## STAFF REPORT

**FILE NUMBER:** H-24-53

**REQUEST:** Rezoning from CPDP (Combined Planning Development Project) with GC (General Commercial) and SF (Single-family) uses, and CPDP (Combined Planning Development Project) with OP (Office Professional) and Congregate Care Facility uses, to PDP(MF)/ Planned Development Project (Multifamily).

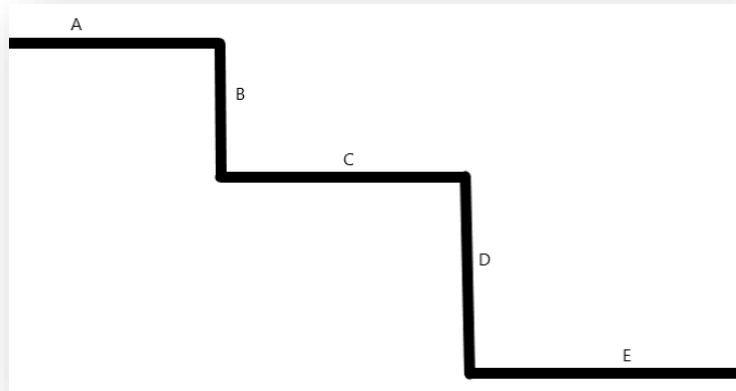
**Comments:** Staff recommend approval of deviations 2 and 3. The petitioner offers buffers that are larger than the minimum requirement. Staff feel it is an appropriate compromise, larger buffers for reduced lot size and setbacks. The topography of the property and the desire to preserve as many specimen and majestic trees as well as the wetlands that run through the property are a few of the reasons the petitioner is requesting the reduction in lot size and setbacks.

Consistent with the Board direction of no side yard setbacks under 7.5', with regards to deviation 4, staff recommend a 2.5' deviation in the side yard setback making the side yard setback 7.5' and reducing the building separation from twenty (20) feet to fifteen (15) feet. The petitioner has stated that they want to preserve as many specimen and majestic trees as possible using with targeted and limited land grading. The preservation of any existing specimen and majestic trees is no longer a standard practice within Hernando County. Amid the clear-cutting and mass graded properties that have become severe nuisances to adjacent property owners, staff believe targeted grading and land clearing resulting in the preservation of valuable community assets (specimen and majestic trees), in exchange for the reduction to the front and side yard setbacks and reduced lot size, is acceptable. Staff encourage the Board to consider the requested five (5) foot reduction in the side yard setbacks.

If approved, the individual lot setbacks and lot size would be:

- Front: 20'
- Rear: 15'
- Building Separation: 10'
- Minimum lot size: 2,640 square feet

Figure 1: Property Lines of the Northeast portion of the project

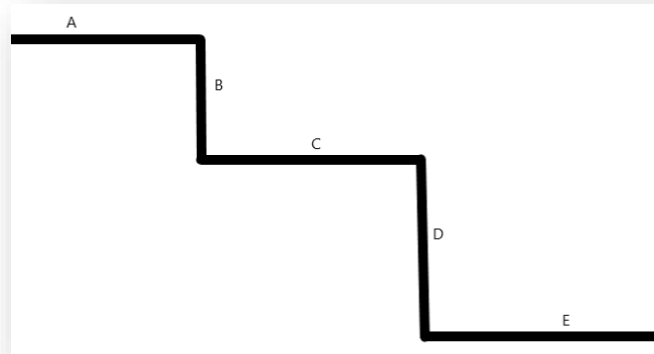
**E. Perimeter Setbacks (including the vegetated buffer) (see figure 1)**

- North (Cortez Boulevard (SR 50)) (A): 75'
- North (C & E): 30'
- South: 45'
- East (Emerson Rd): 35'
- East (B and D): 30'
- West (Oxley Road): 45'

**F. Buffers (see figure 1 for a visual representation of the northeast buffer locations)**

- North (A) (Cortez Boulevard (SR 50)): 45' Landscaped Buffer
- ~~North (C): 30' Landscaped Buffer~~ 5' Landscape Buffer against existing FDOT drainage retention pond
- North (E): 5' Landscaped Buffer
- South: 15' Landscaped Buffer
- East (Emerson Rd): 35' Landscaped Buffer

- East (B): 15' Landscaped Buffer
- East (D): 5' Landscaped Buffer
- West (Oxley Road): 20' Landscaped Buffer

Figure 2: Property Lines of the Northeast portion of the project

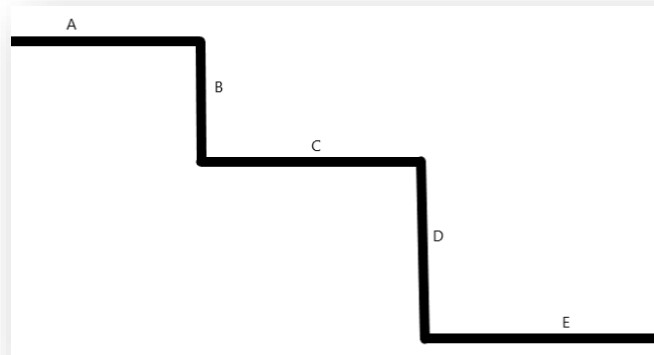
E. Perimeter Setbacks (including the vegetated buffer) (see figure 1)

- North (Cortez Boulevard (SR 50)) (A): 75'
- North (C & E): 30'
- South: 45'
- East (Emerson Rd): 35'
- East (B and D) 30'
- West (Oxley Road): 45'

F. Buffers (see figure 1 for a visual representation of the northeast buffer locations)

- North (A) (Cortez Boulevard (SR 50)): 45' Landscaped Buffer
- ~~North (C): 30' Landscaped Buffer~~ 5' Landscape Buffer against existing FDOT drainage retention pond
- North (E): 5' Landscaped Buffer
- South: 15' Landscaped Buffer
- East (Emerson Rd): 35' Landscaped Buffer
- East (B): 15' Landscaped Buffer
- East (D): 5' Landscaped Buffer
- West (Oxley Road): 20' Landscaped Buffer
